REQUEST FOR INFORMATION **DATE:** May 16, 2016 **NO.:** RFI-083

Project Name: Webster University Interdisciplinary Science Building Project No.: 15051

Subject: Curtain wall structural clarifications

4 ENLARGED DETAIL @ CURTAINWALL PARAPET
1 1/2" = 1'-0"

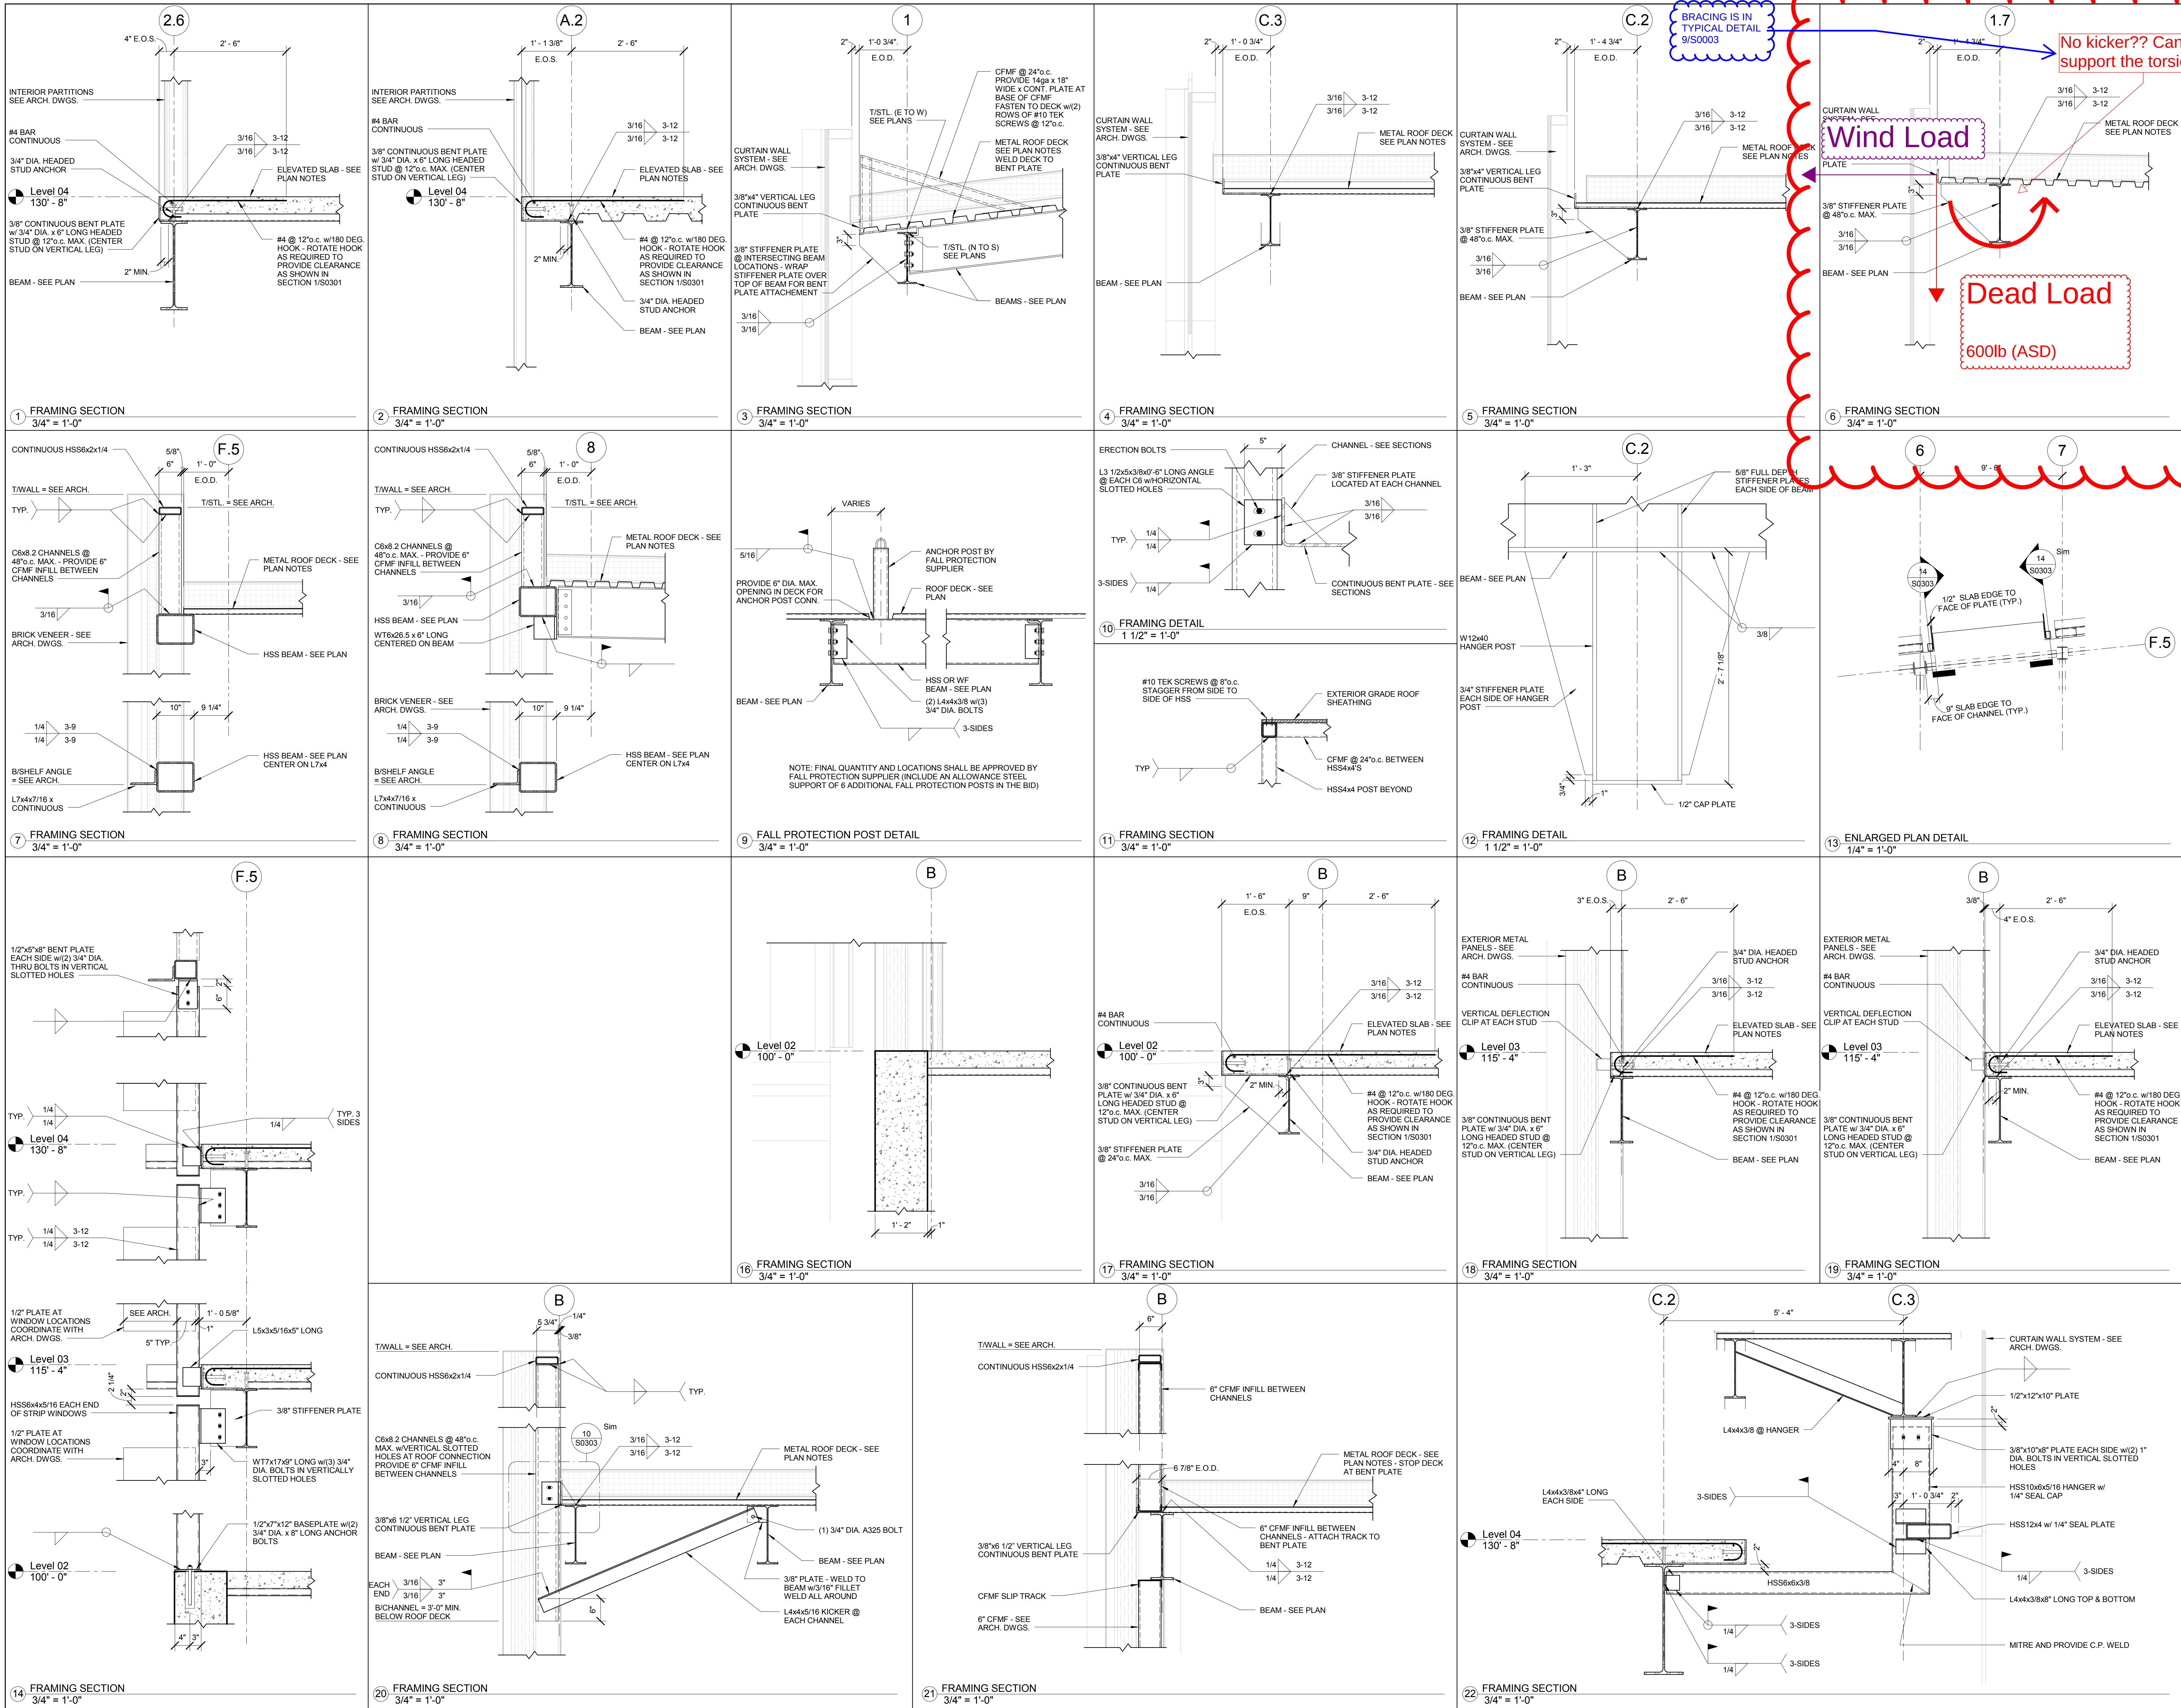
1. Detail 4/A0451 is currently drawn as a dead load connection to roof structure. Detail 5/A0453 is currently drawn as wind load connections to the third and fourth floor structure. There is currently stack joints drawn in between the third and fourth, and the fourth and roof. This is unstable, as the section of curtain wall running past the fourth floor line does not have its weight supported.

Response to Questions 1, 2, 3:

Attached drawings (Horizontal Movement Clarification) with markups add further clarification to design intent in the documents. If you have further questions we can have a discussion.

A0453

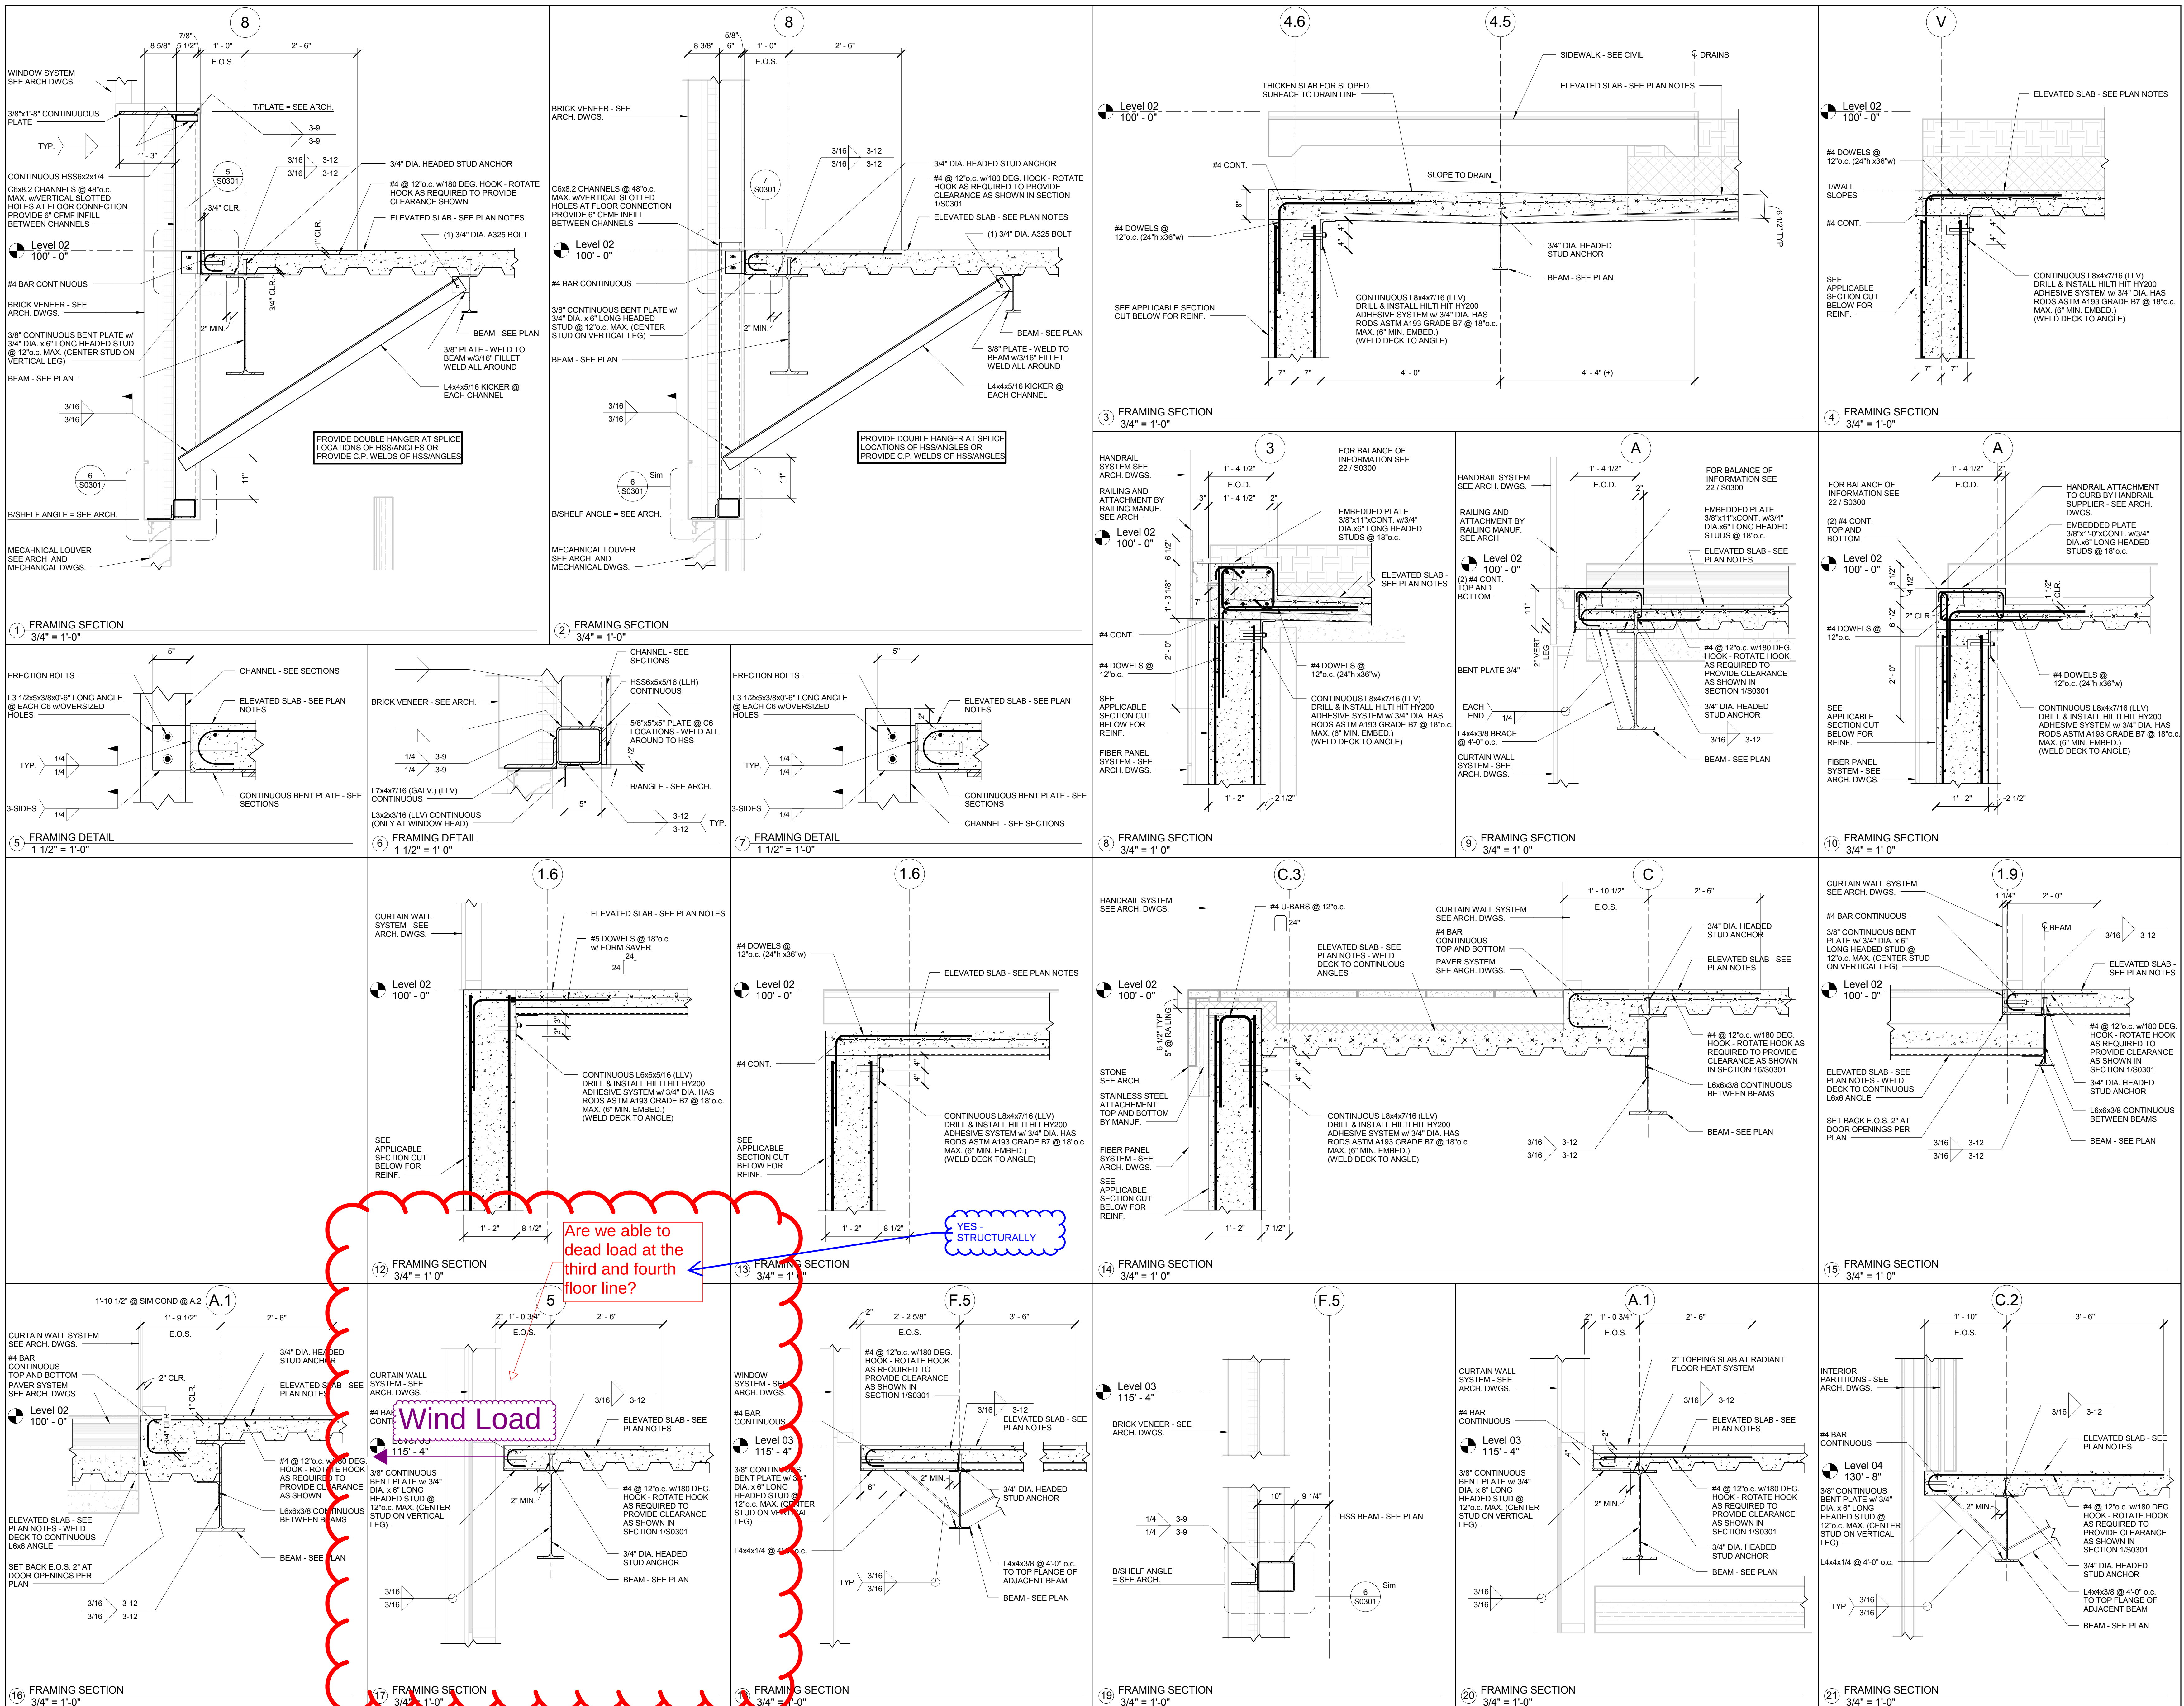
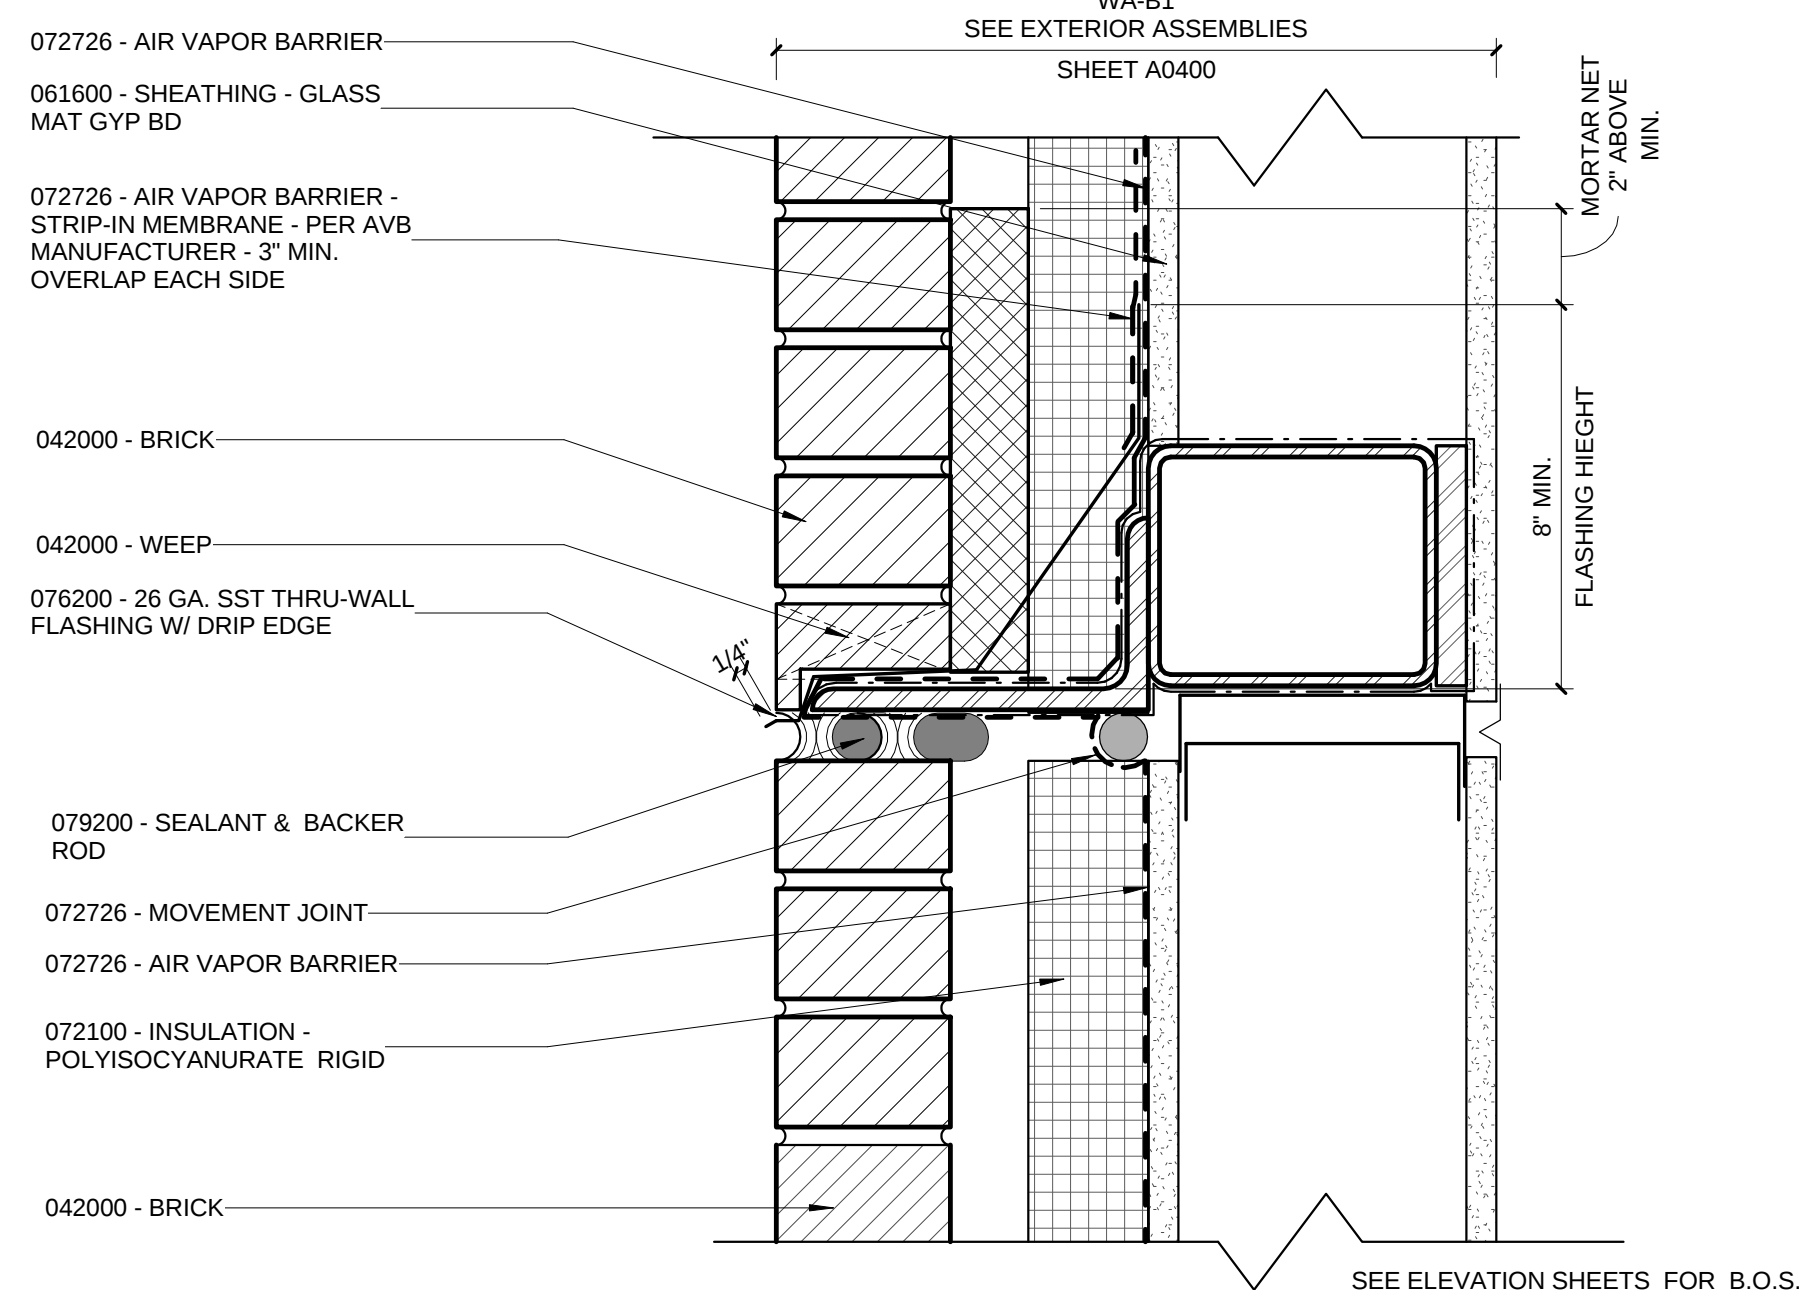
Are we able to
dead load at the
third and fourth
floor line?

CONSIDER MOVING
BRACE UP TO
BOTTOM FLANGE

YES -
STRUCTURALLY
